## N232426400 Tailgate May Open Unexpectedly

Release Date: May 2024 Revision: 04

Revision Description: This bulletin has been revised to update the service procedure to include a requirement

666218

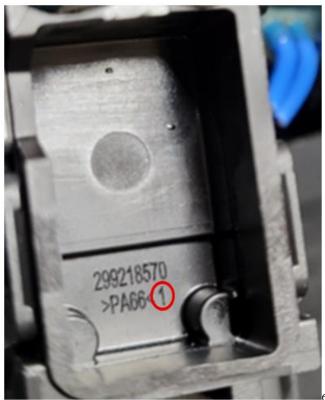
#### IMPORTANT: BEFORE INSTALLATION, YOU MUST INSPECT THE PART PER INSTRUCTIONS BELOW.

- Inspect the number shown on the replacement switch.
  - If the last digit is "1", the part is BAD and MUST be scrapped.
  - If the last digit is anything other than "1", the part is good and can be installed in the vehicle.
